STANNAH LIFTS LTD

**TECHNICAL BULLETIN****INFORMATION ONLY**

**For the Attention of :** Installers, Testers, Trade Customers, Training Dept,**Date :** 21/12/09**Product :** Traction Passenger Lifts - Maxilift**Subject :** Changes to Uninterruptable Power Supply (UPS)**Status :** Product Update - Information only**Pages :** 2

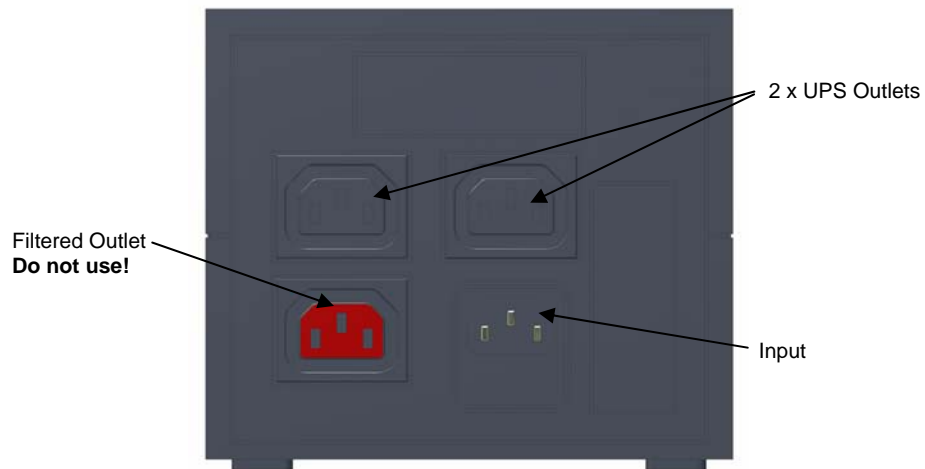
The model of UPS used on traction lifts has changed from ref. ERA 1.0 to ref. ERA LCD 1.1 due to the previous unit being discontinued by the manufacturer. The new model is identifiable by an LCD screen located on the front of the unit.

The new unit, due to its revised overall dimensions should now be mounted on its side with the base towards the control panel backplate as shown. Secure the unit to the backplate with cable ties ensuring the eye of the cable tie is clear of the cabinet door stiffener. A cut-out has been added to the door stiffener to prevent any interference as this may result in difficulty in closing the door.

Connections to UPS are unchanged and are labelled on the unit.

Note: The red "Filtered Outlet" is **not** used.
